Legends Resort & Casino

Bid Package 1 – Envelope

Addendum No. 02

Date: July 7, 2023

LEGENDS CASINO // LIGHTBOXES

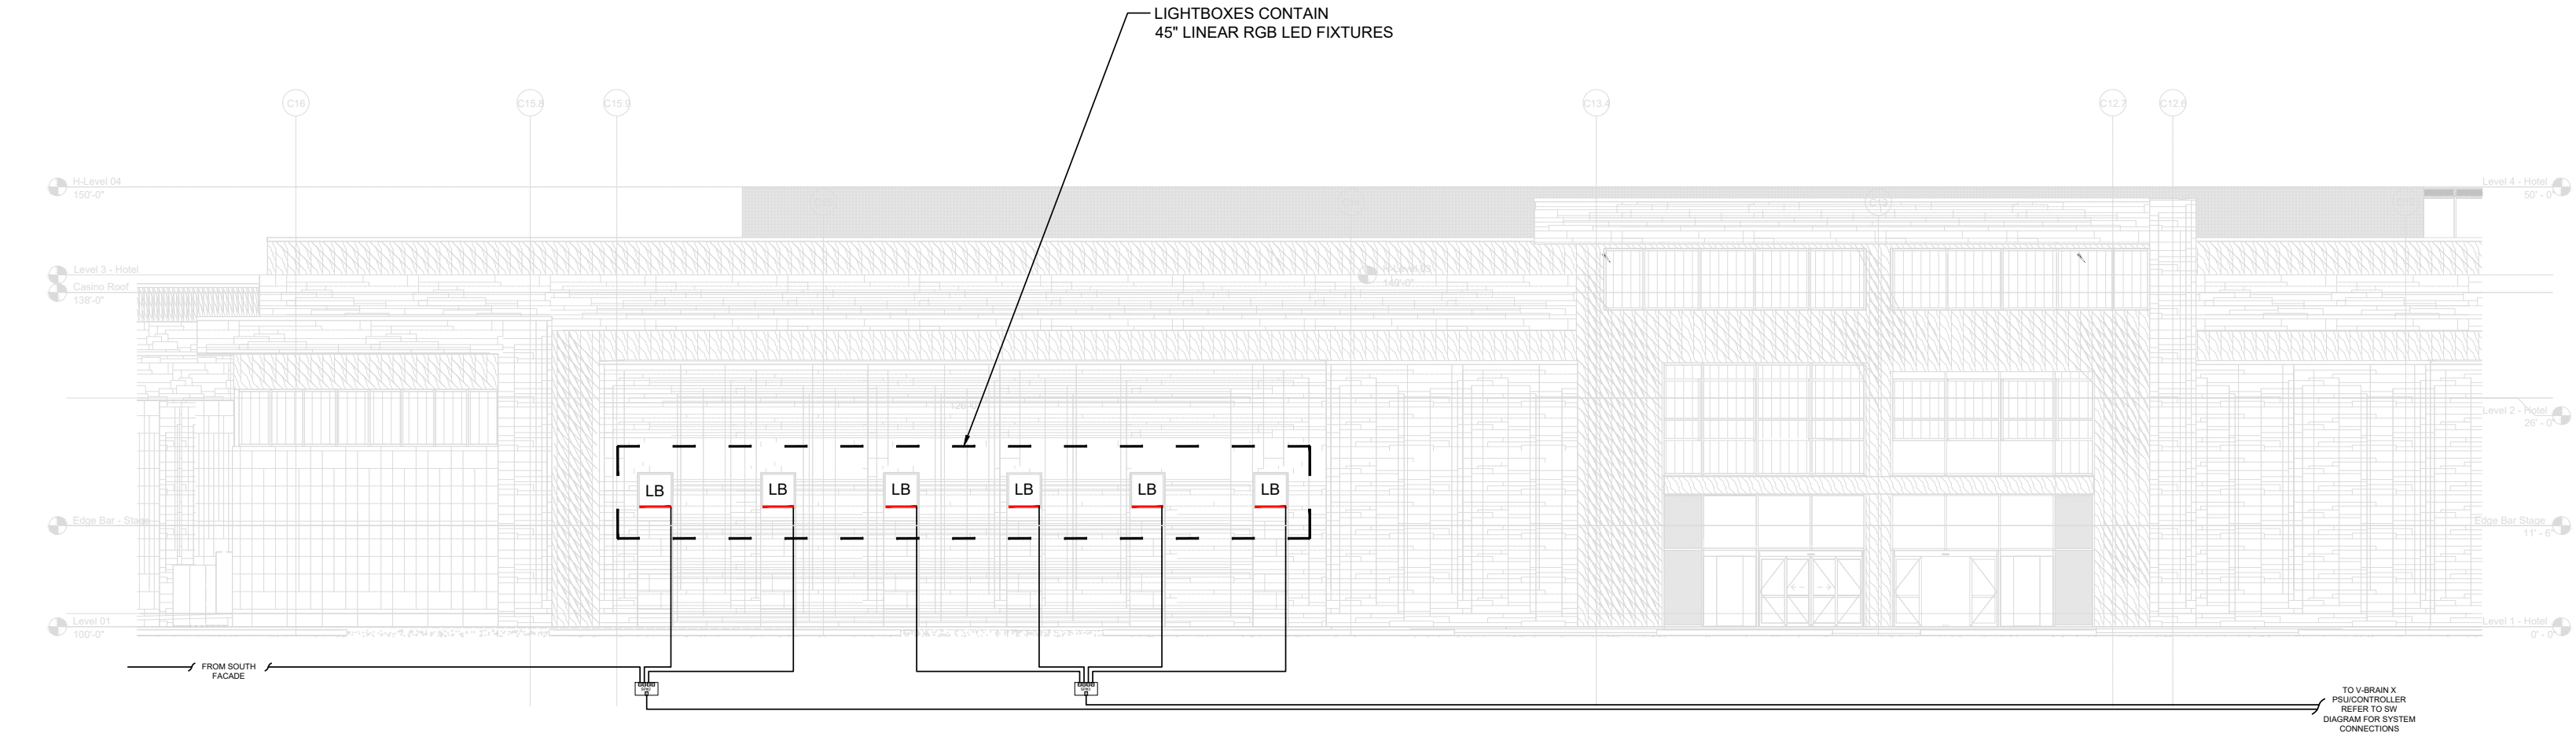
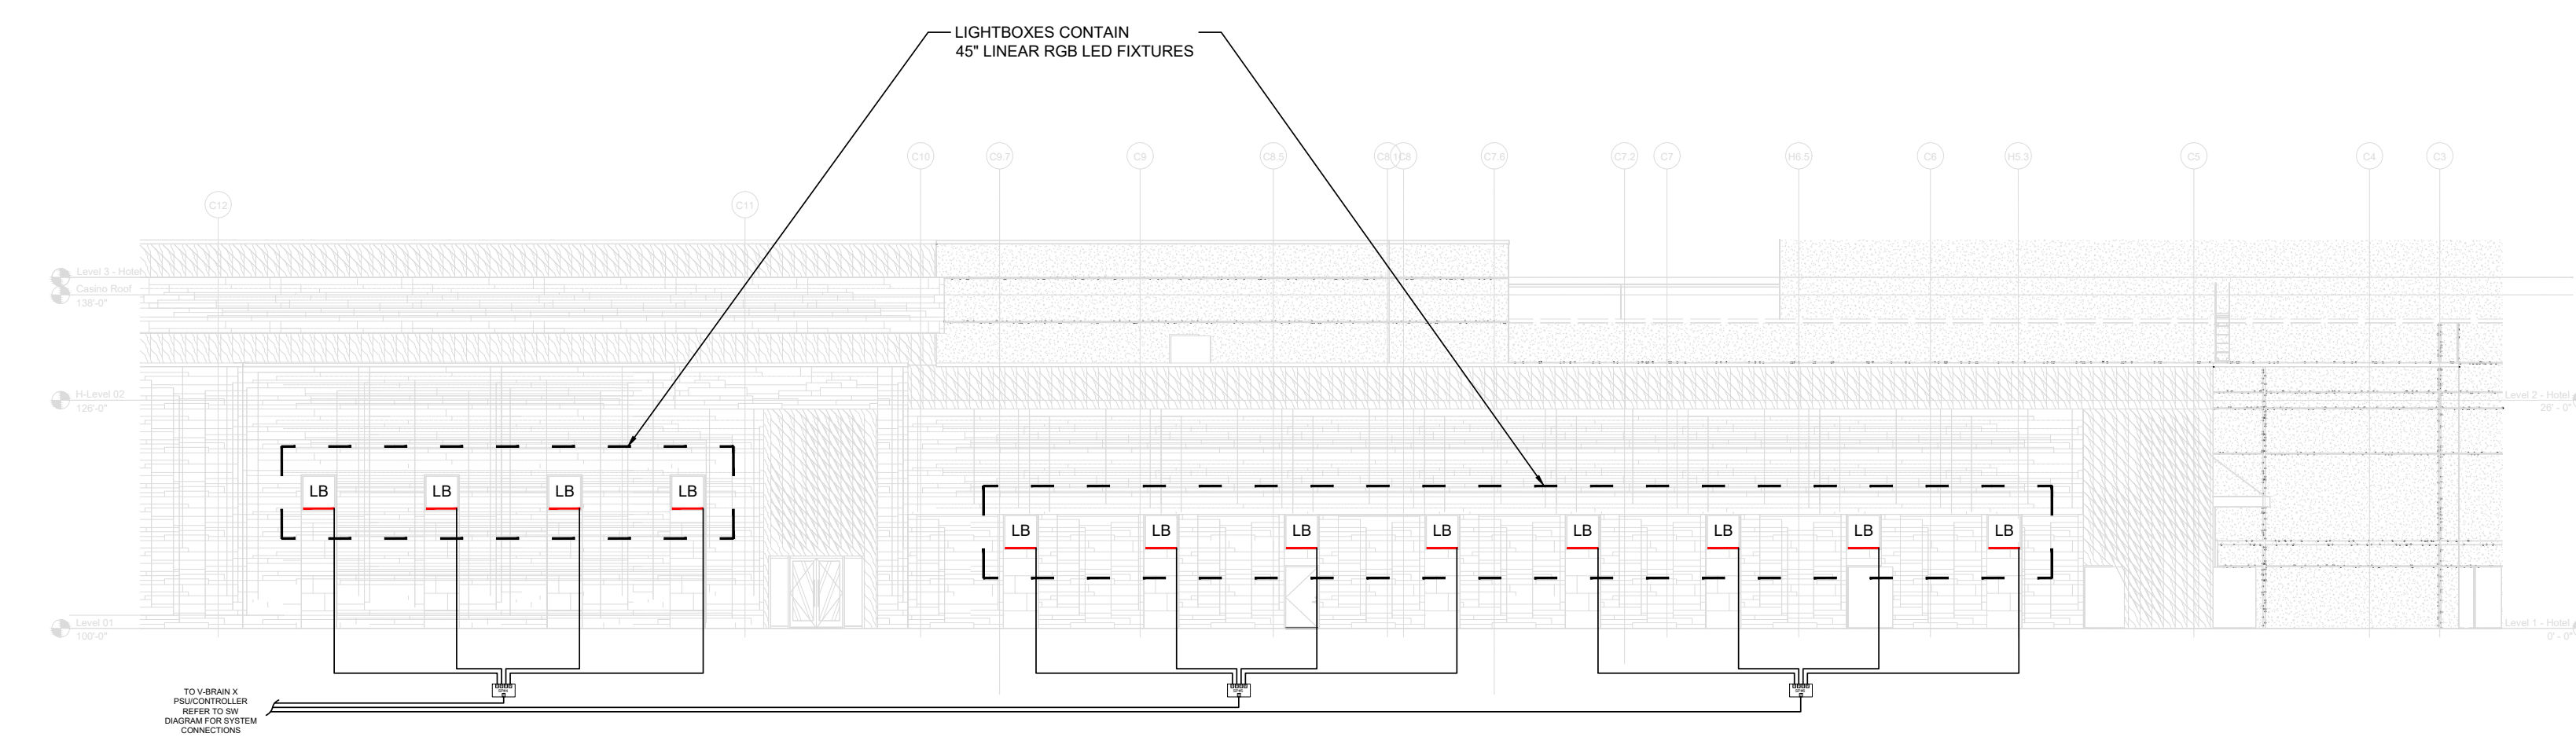
- 04) [Question] Unitized curtain wall system includes mullion mounted exterior strip lighting. Contractor required coordination for this work. We will need additional information regarding the mullion mounted exterior strip lighting so we can confirm attachment to the curtain wall. Also, please confirm that the exterior strip lighting will be by others and that curtain wall contractor will only need to coordinate this work. {This includes all embeds and anchorage.} Please confirm if it's CDI's intent to have the curtain wall contractor supply the embeds for the project.
[Answer] This question is with the design team and response is pending. See the product data attached to this Addendum 02 Q/A narrative sheet labeled as "Appendix A" for the proposed exterior hotel tower strip lighting system for your reference. The proposed manufacturer is SACO's V-Stick lighting system that is to be furnished and installed by the electrical/specialty lighting contractor including mounting accessories to

the curtain wall system. Exterior curtain wall contractor's responsibility is to coordinate with CDI Contractors, the electrical contractor, and the lighting manufacturer prior to final submittal approval and start of curtain wall production. Please assume that the curtain wall contractor will need to include incorporation of a seamless strip lighting design within the curtain wall system.

4b ST 4b - OFF SITE PROJECT ID DIGITAL PYLON SIGN

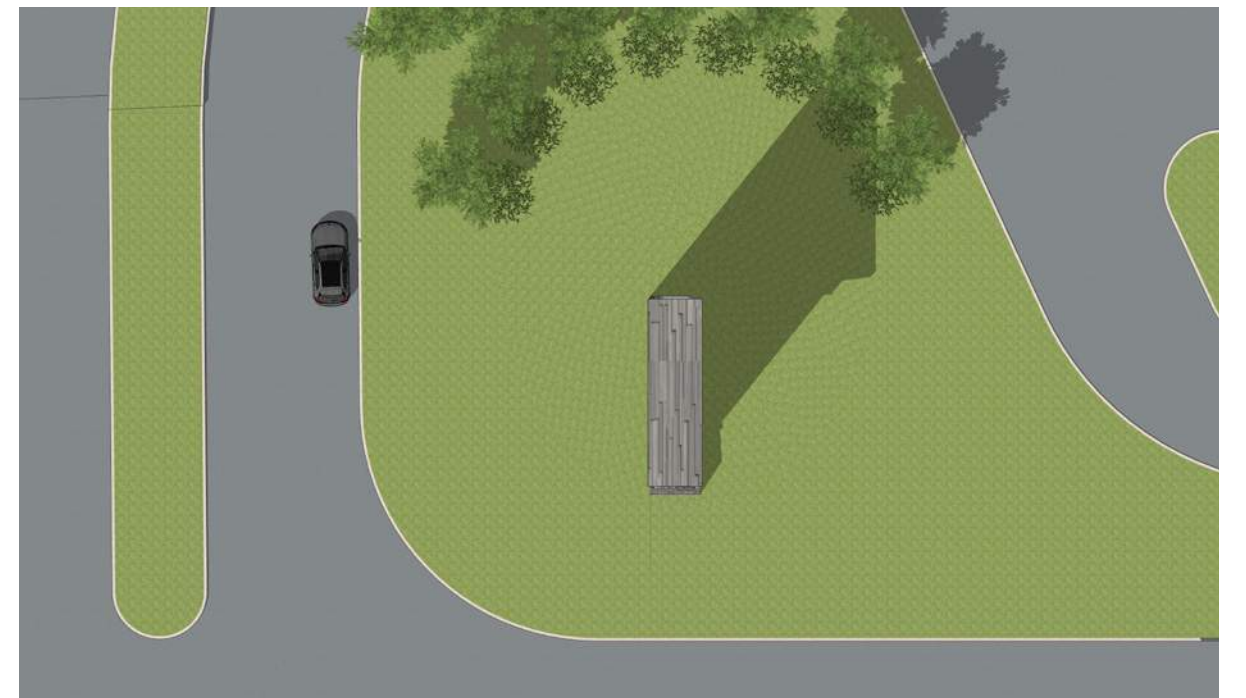
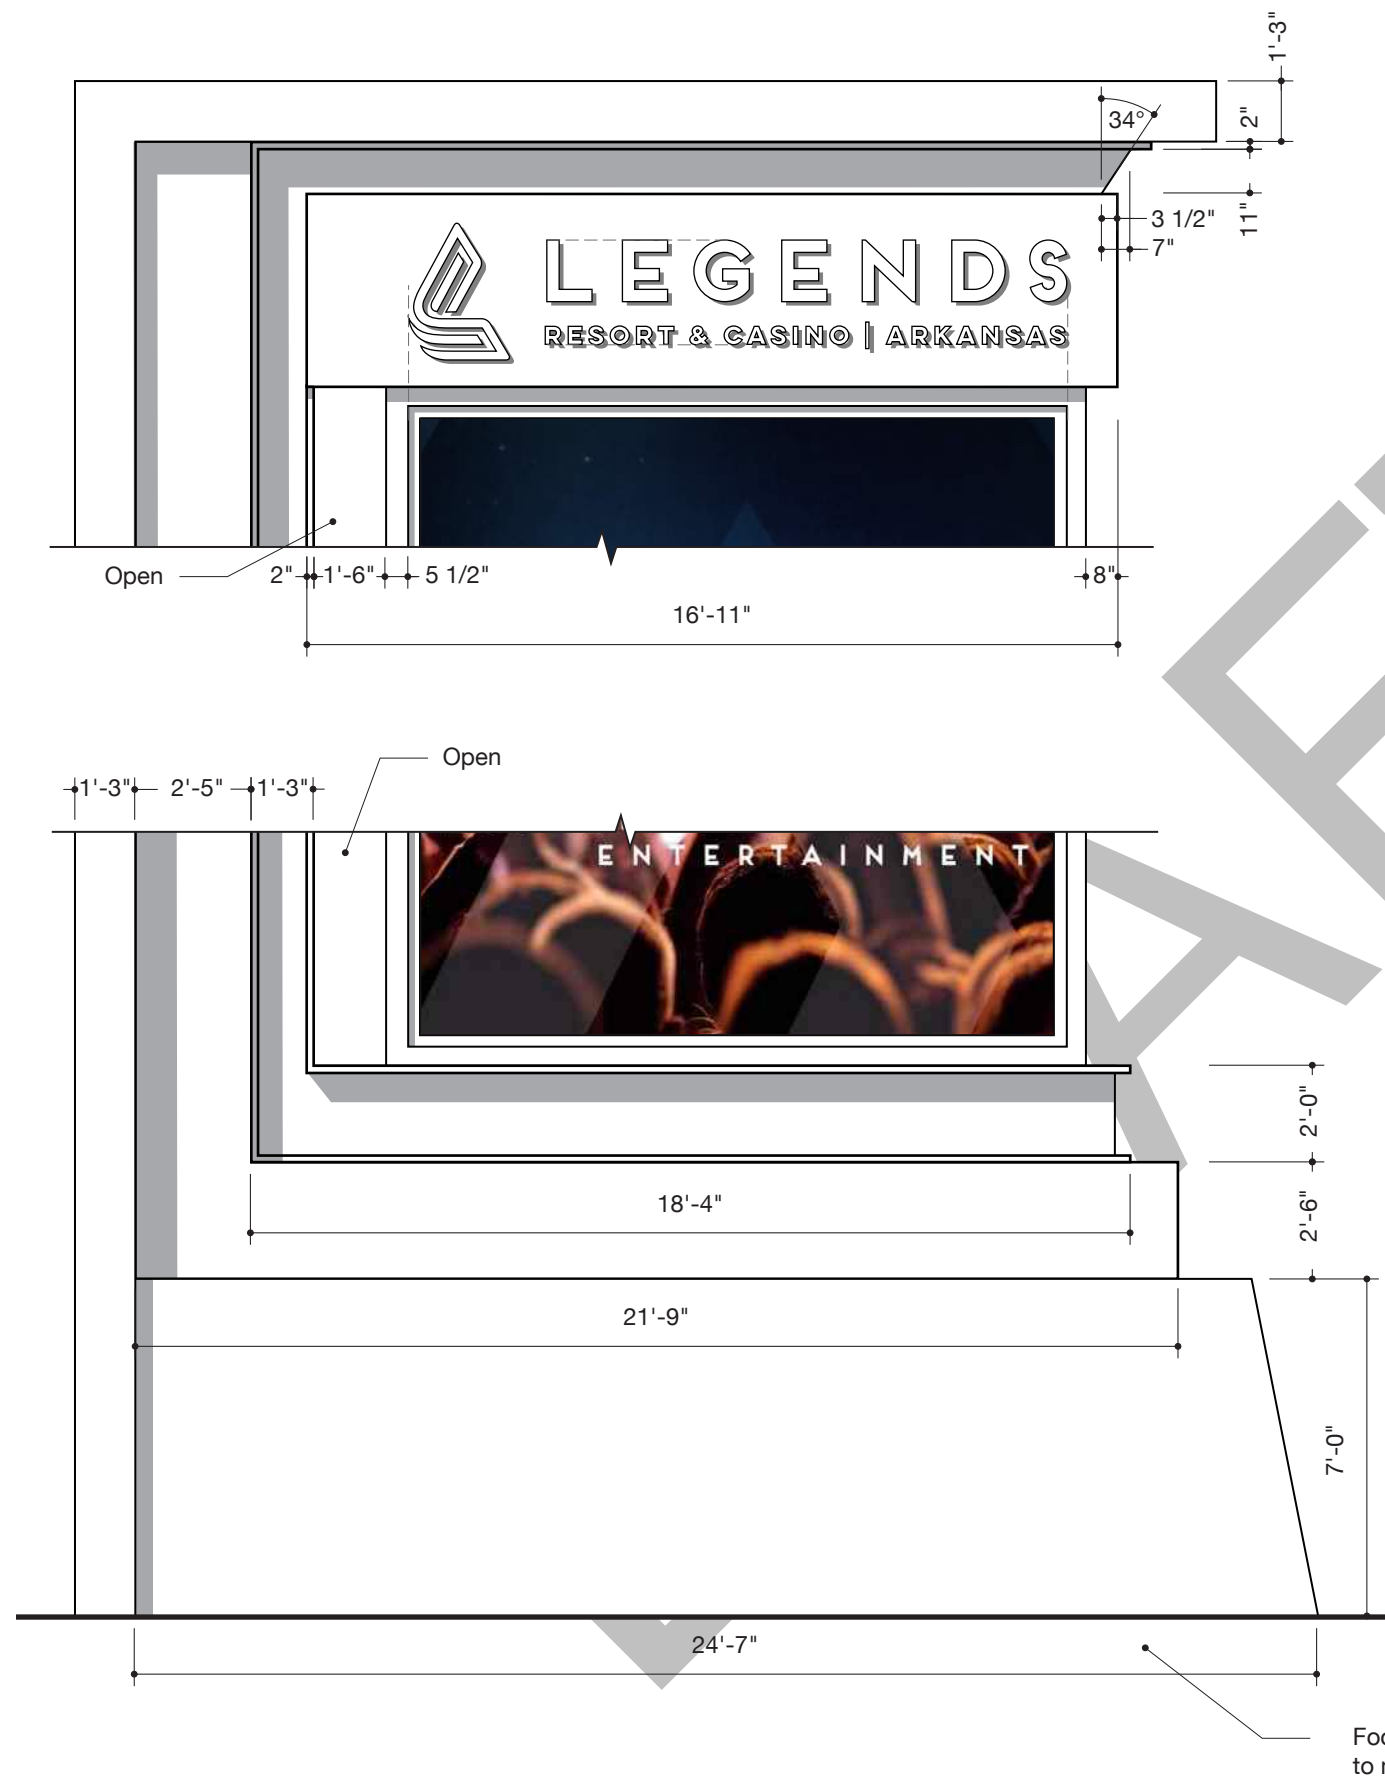
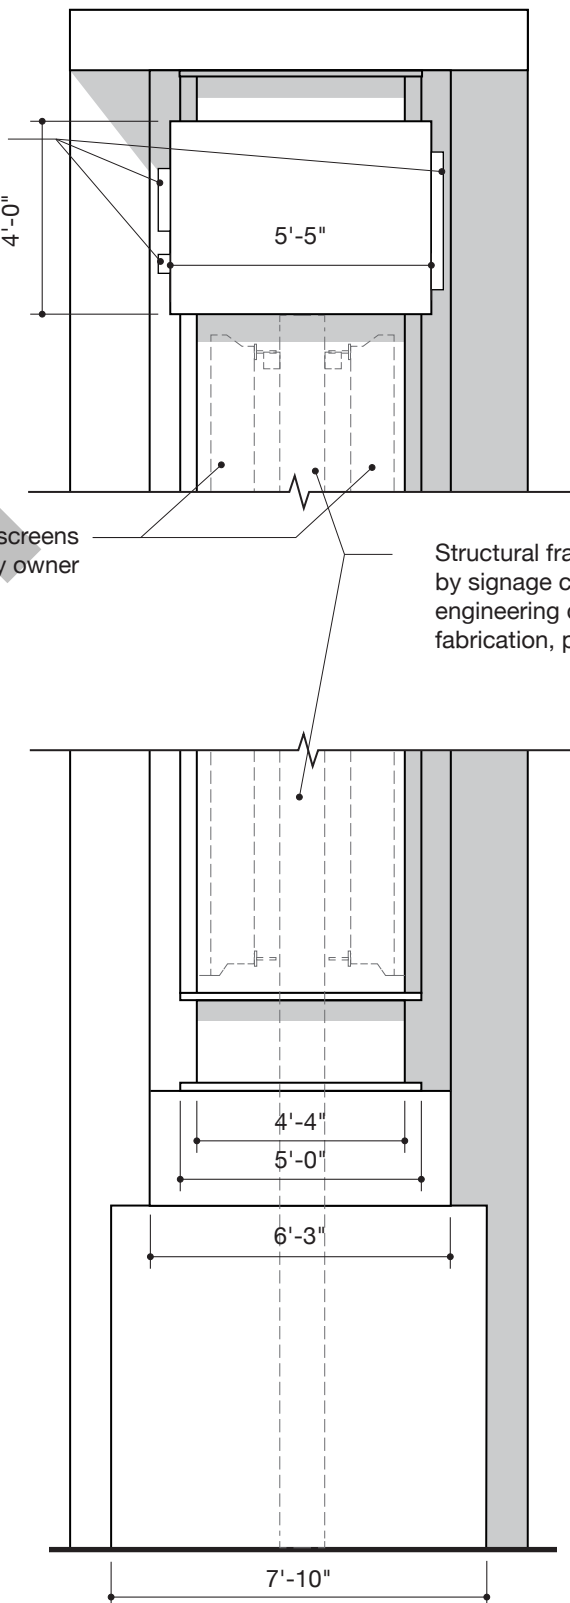
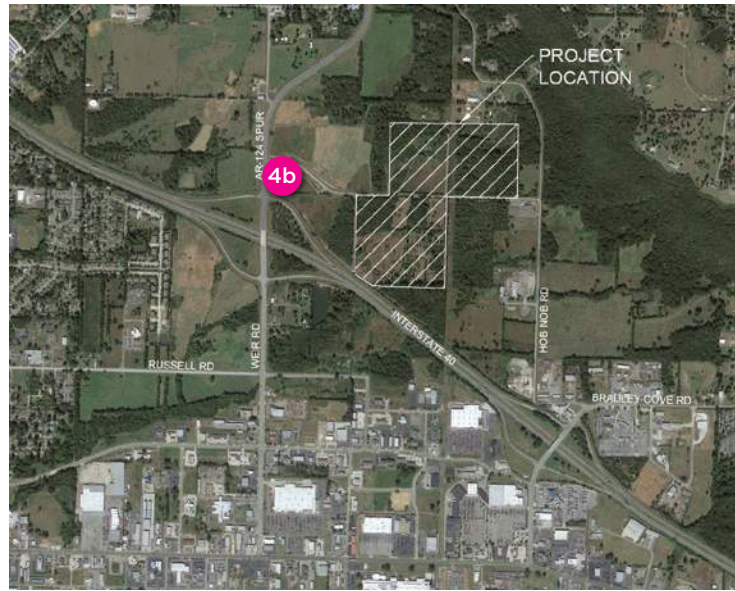
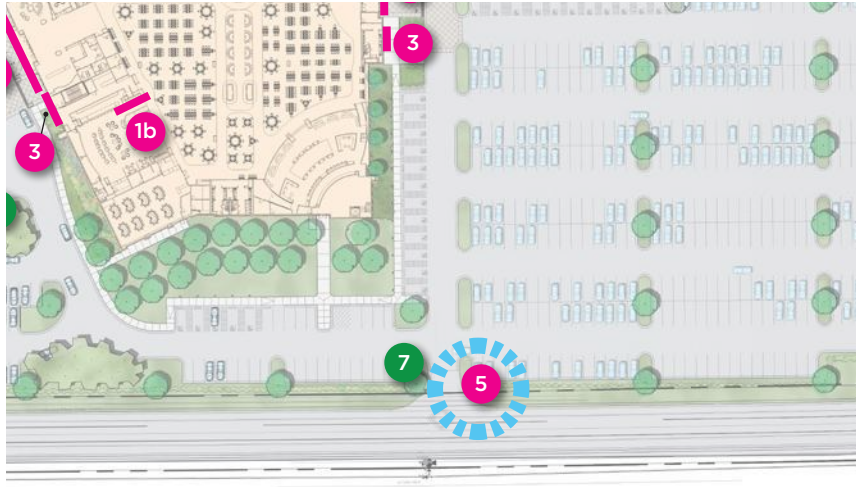
- 08) [Question] The 95% documents were issued on 06/07/23 after the issuance of BP1. During the review of the 95% documents, CDI found notes in the signage package that GFRC cladding is required at several outdoor monument-type sign locations such as signs "4", "4b", and "5" that are not indicated on the current architectural or landscape drawings. Please review with the signage consultant and Legends/CNE and verify if GFRC cladding is required at these (3) sign locations. If yes, provide additional details on these assemblies and verify if any other location signage or miscellaneous independent outdoor locations require GFRC cladding.
[Answer] This question is with the design team and response is pending. See the attached documents issued as part of the 95% signage presentation labeled as "Appendix B". CDI has also revised the GFRC fabrication and exterior framing bid scope sheets to include allowances for furnishing and installing GFRC paneling at the three monument sign locations labeled "4", "4b", and "5". See CDI's dimension mark-ups on "Appendix B" for estimating assumptions for the monument signs.
